APPEAL SUMMARY

Appeal ID: 23429	Project Address: 2400 NE Broadway St
Hearing Date: 2/5/20	Appellant Name: Joshua Klyber
Case No.: B-020	Appellant Phone: 5032091458
Appeal Type: Building	Plans Examiner/Inspector: Chanel Horn
Project Type: commercial	Stories: 1 Occupancy: A-2, F-2 Construction Type: V-B
Building/Business Name: Broadway Brewery	Fire Sprinklers: Yes - Throughout
Appeal Involves: Alteration of an existing structure	LUR or Permit Application No.: 19-248077-LU
Plan Submitted Option: pdf [File 1]	Proposed use: Brewery

NE BROADWAY BREWERY

PROPOSED BUILDING ELEVATION - EAST 2
1/8" = 1'-0"

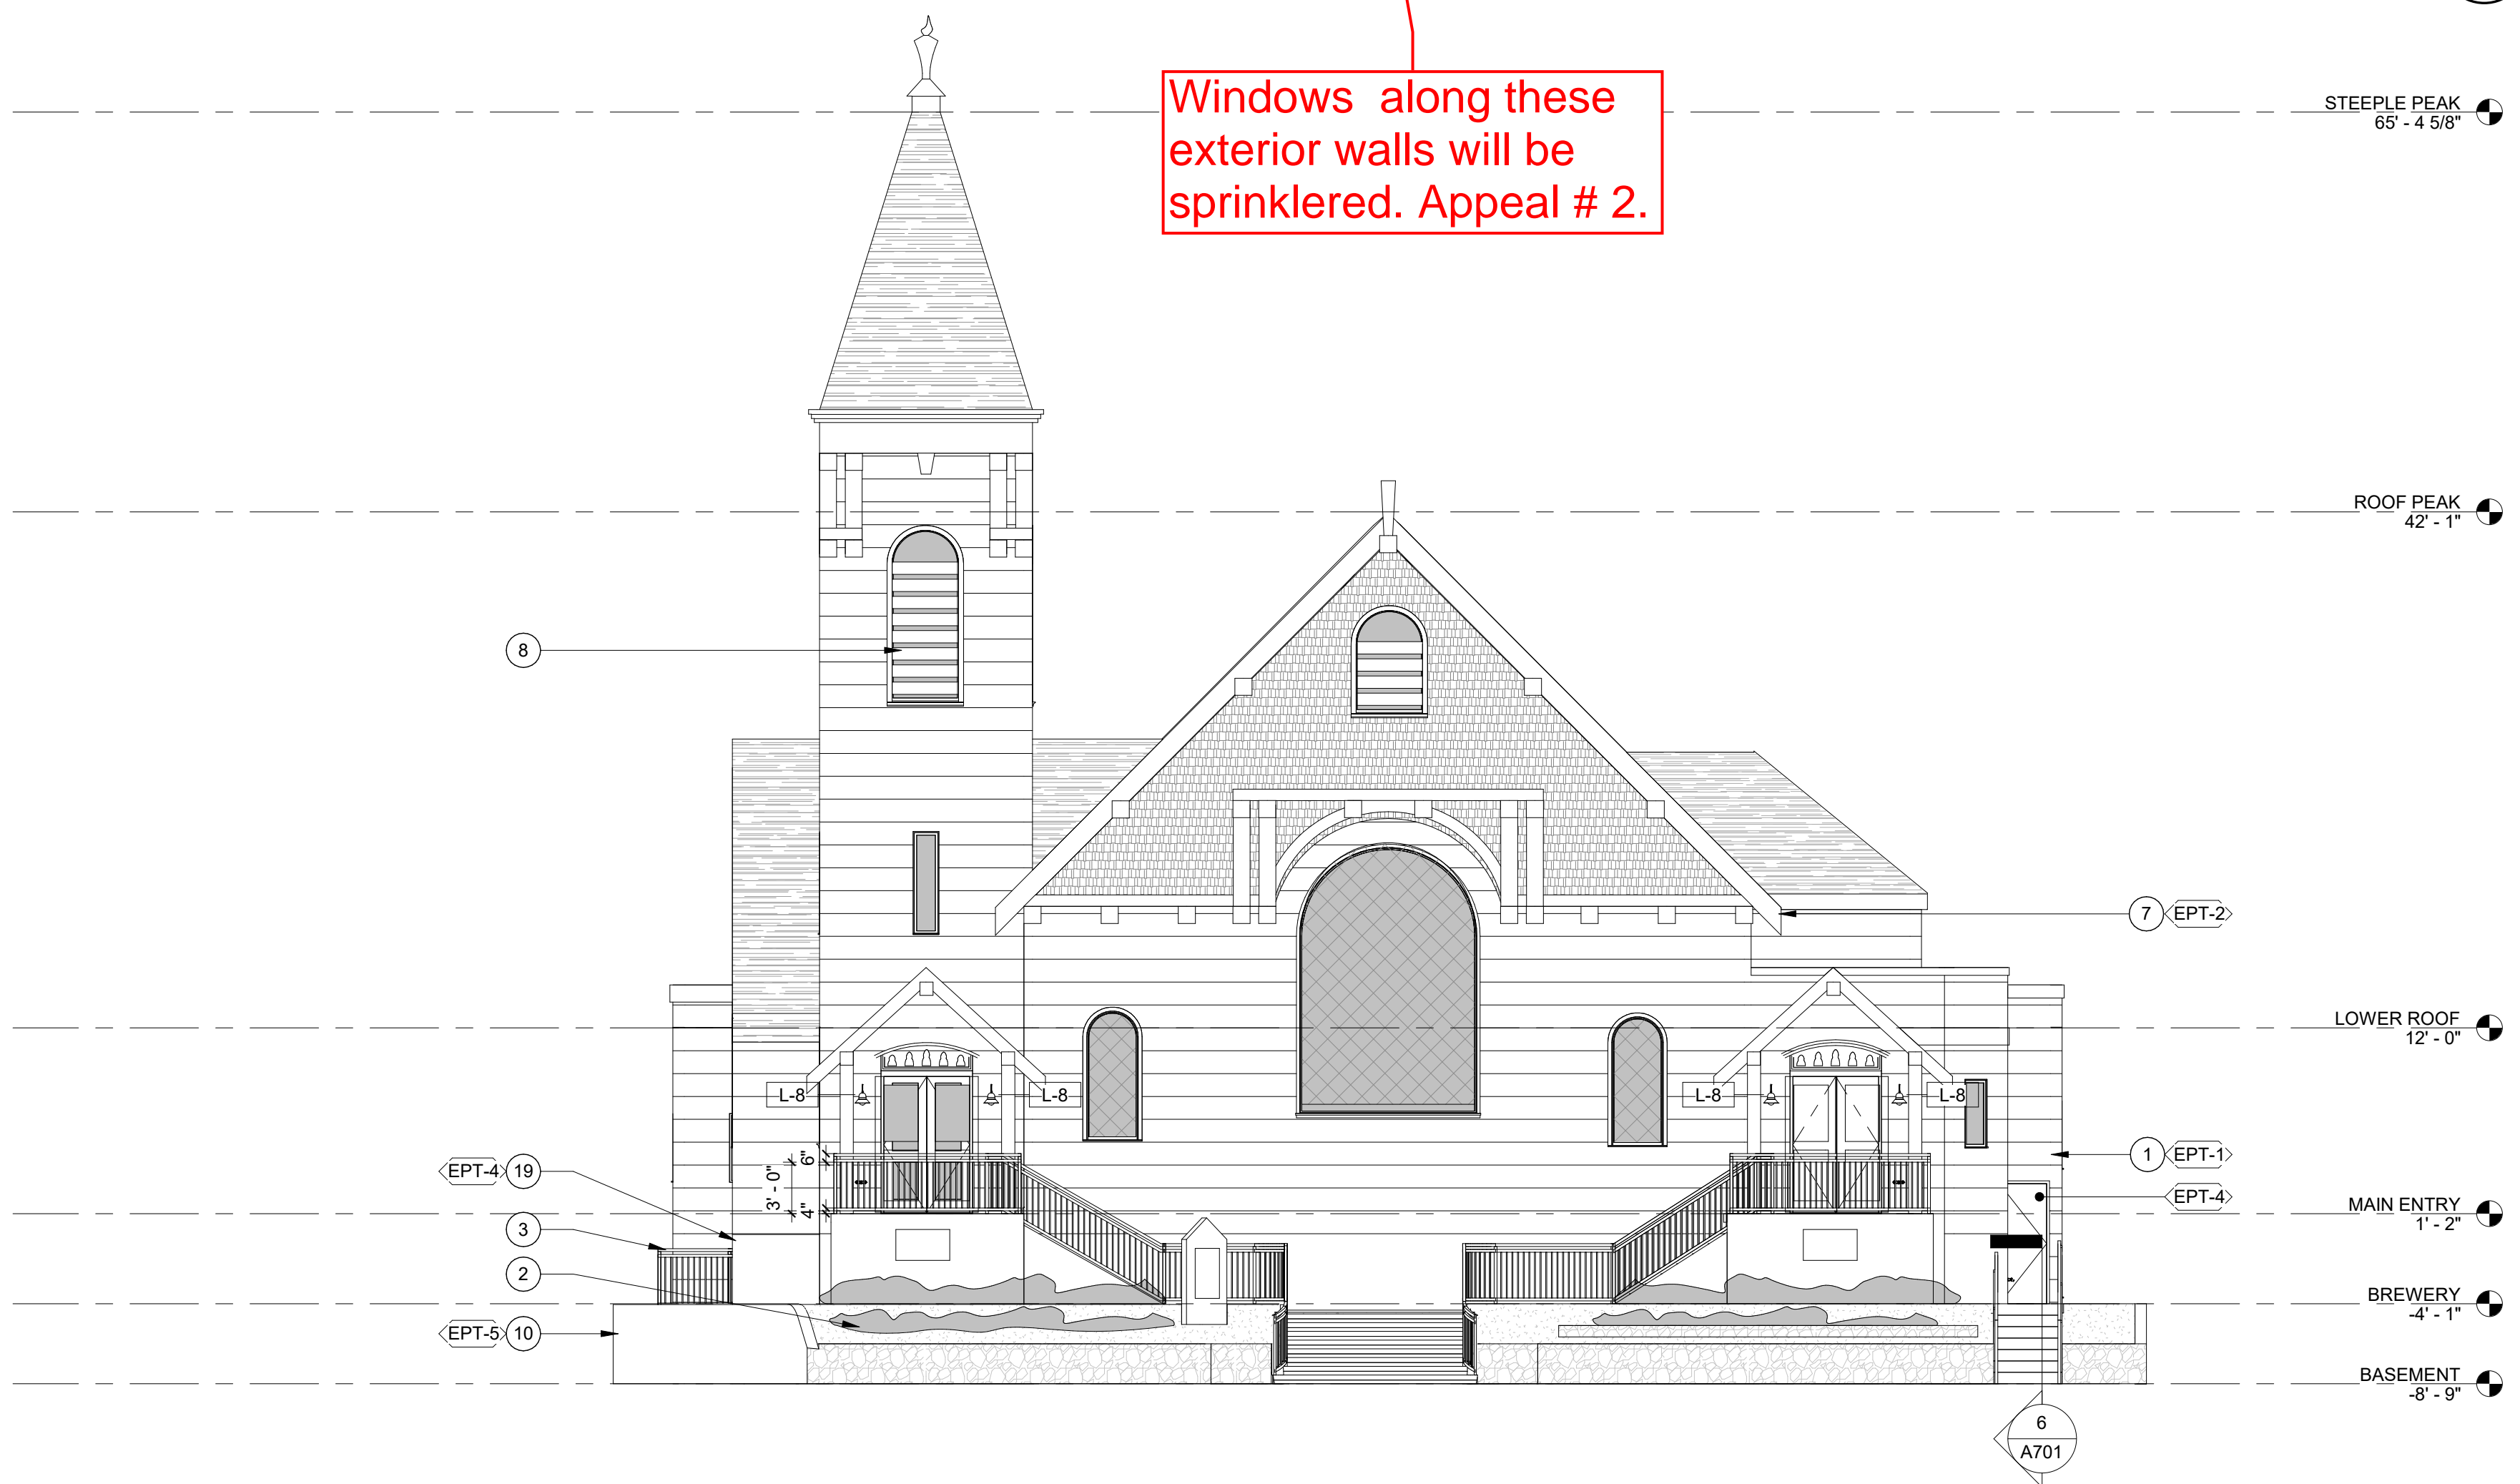
Proposed Design The Broadway Brewery is Type-VB construction and will be fully sprinklered. The east façade of the building is located one-foot one-inch from the property line. A portion of the building on the south side is located one-foot one-inch from the property line. A separate portion of the south façade is seven-feet one-inch from the property line. All three (3) do not have adequate Fire Separation Distance to allow for existing unprotected openings per OSSC Table 705.8.

Windows along these exterior walls will be sprinklered. Appeal # 2.

- 1. Use of ship's ladder to access brewery tanks: Hold for additional information.**
- 2. Type 13 water curtain sprinkler protection at non-fire rated openings in exterior walls where openings are not allowed: Denied. Proposal does not provide equivalent Life Safety protection.**
- 3. Type 13 water curtain sprinkler protection at non-fire rated openings in exterior walls of egress court less than 10' in width: Granted provided windows are non-operable, and sprinklers are spaced not more than 6 feet apart and placed a minimum of 6 inches and a maximum of 12 inches from the opening(s) and a maximum of 12 inches below the ceiling. Sprinklers are to be installed on the occupied side of the openings. A separate permit from the Fire Marshal's Office is required.**
- 4. Exemption from high hazard occupancy classification for grist milling system: Hold for additional information.**

MAIN LEVEL - CODE PLAN

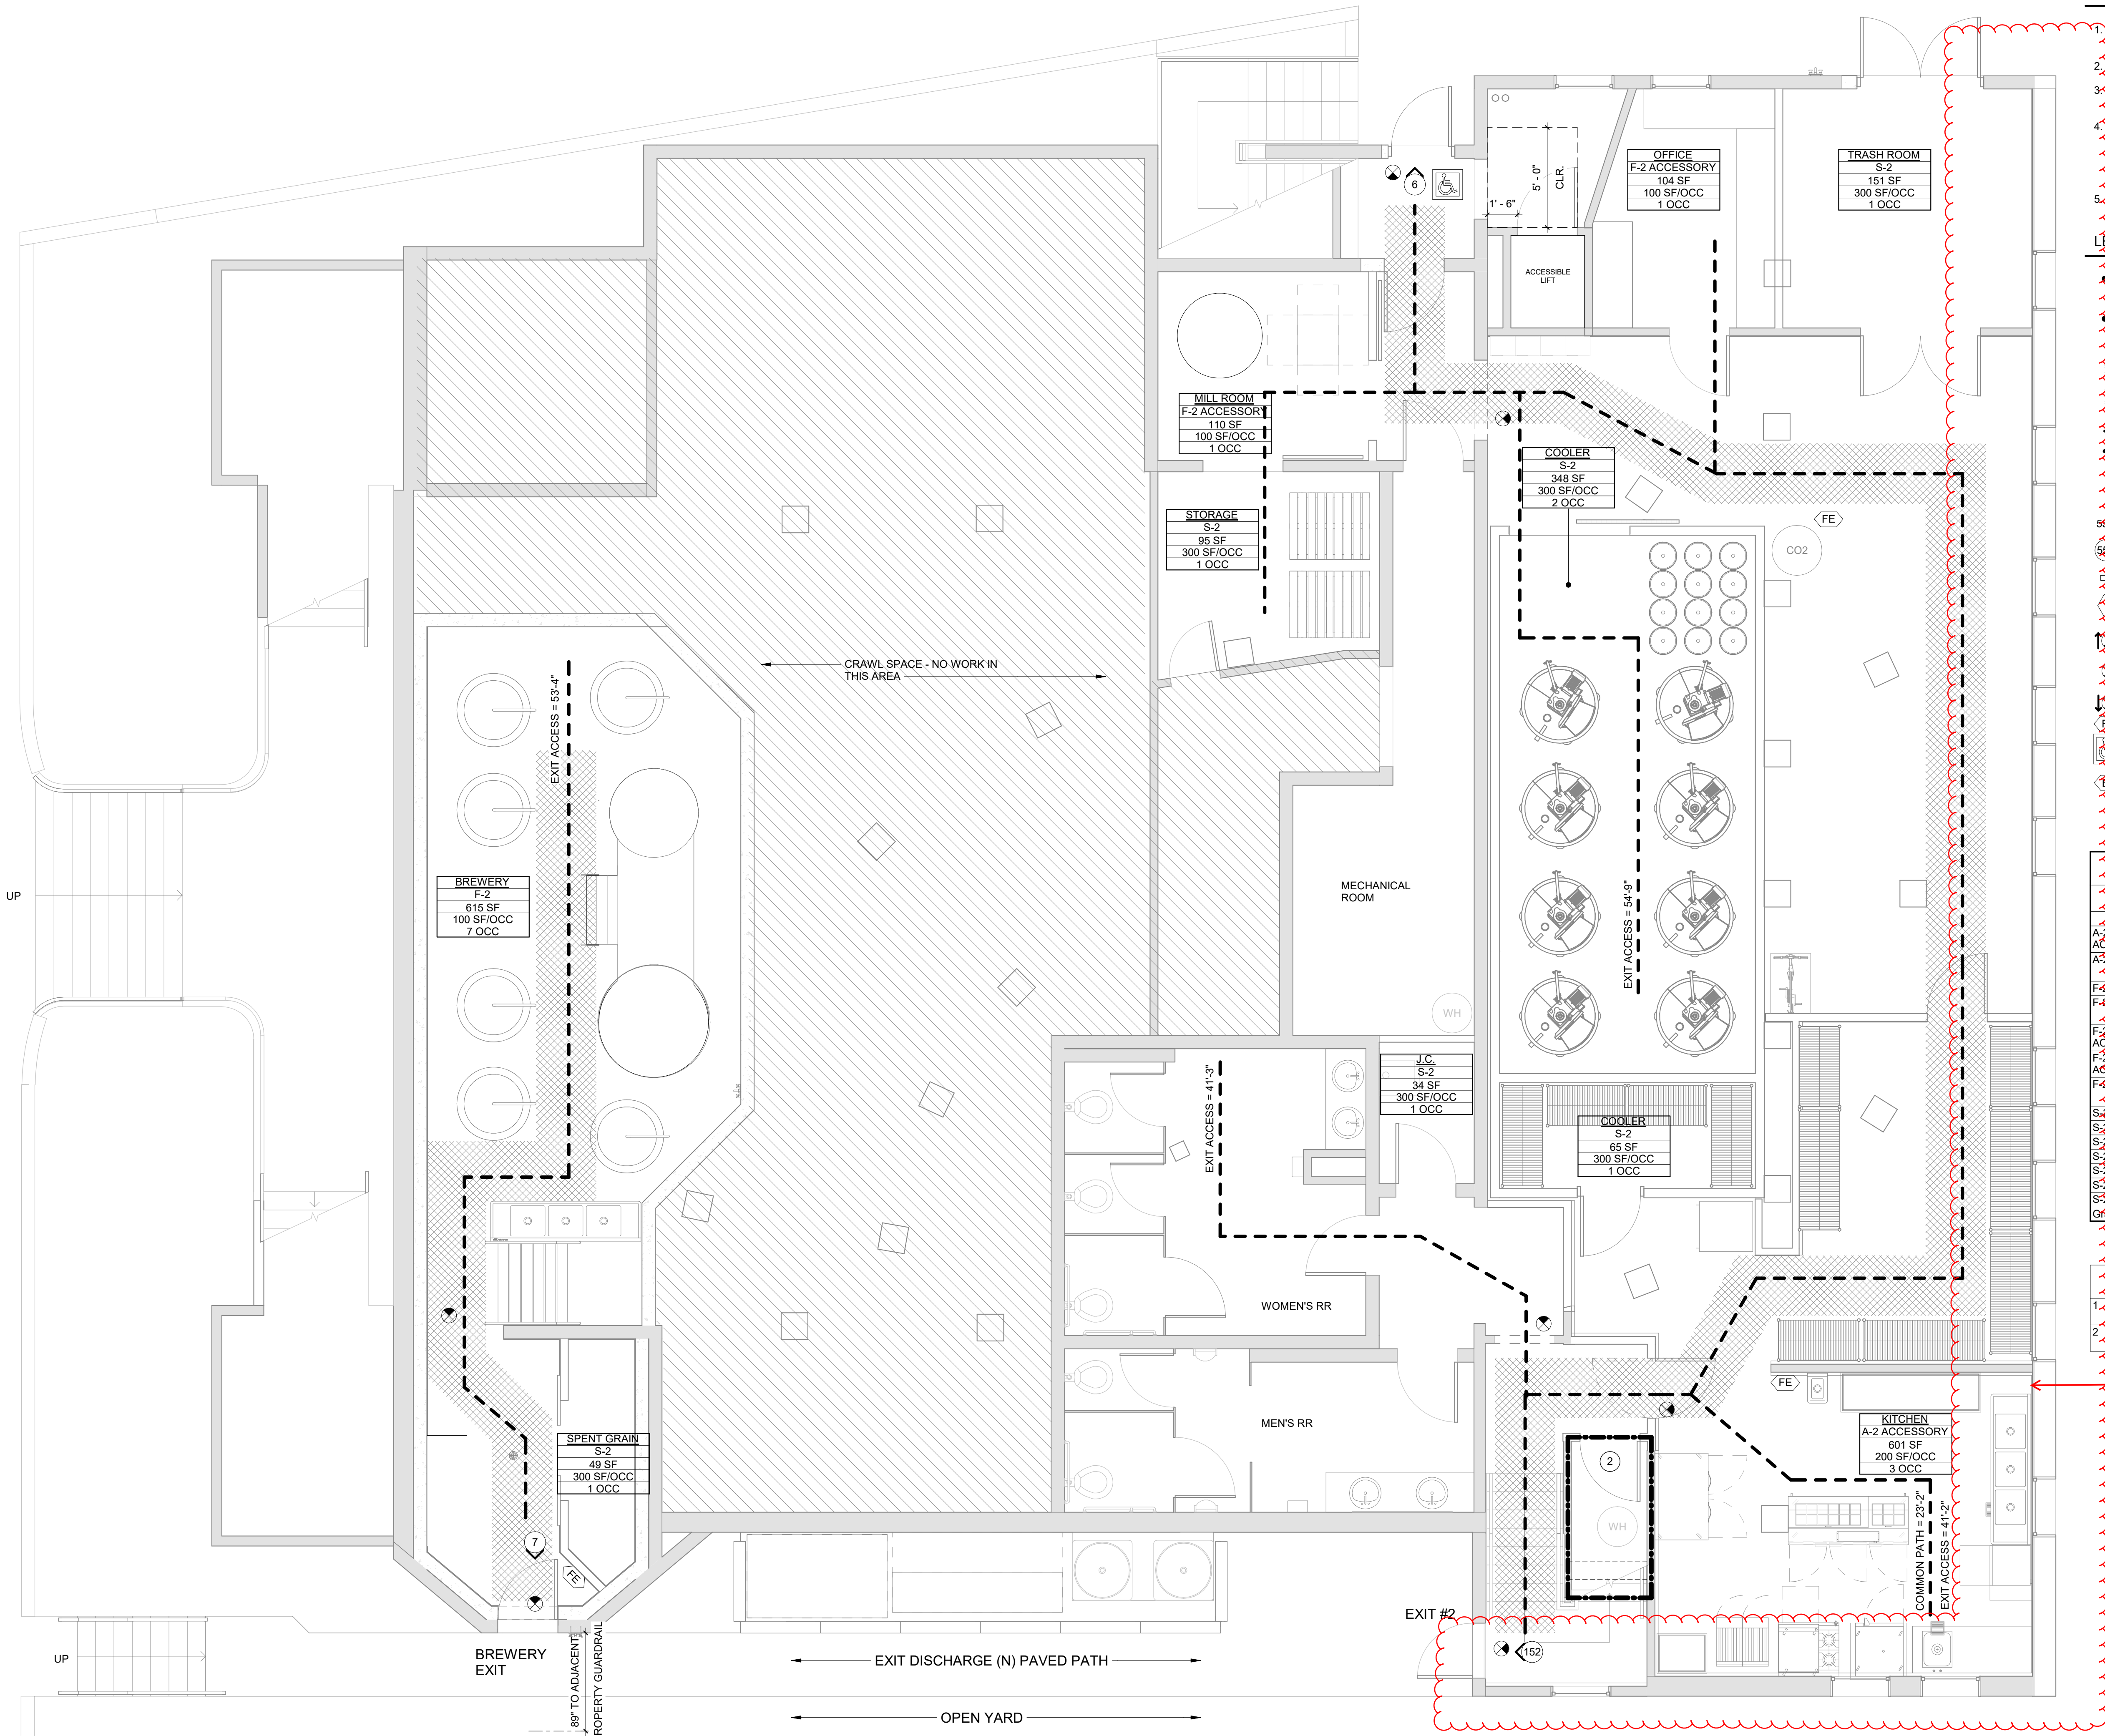
Windows along these exterior walls will be sprinklered. Appeal # 2.

Windows at this location will be sprinklered. Appeal # 3.

Convenience ship's ladder at this location. Appeal # 1.

Grain Milling Room at this location. Appeal # 4.
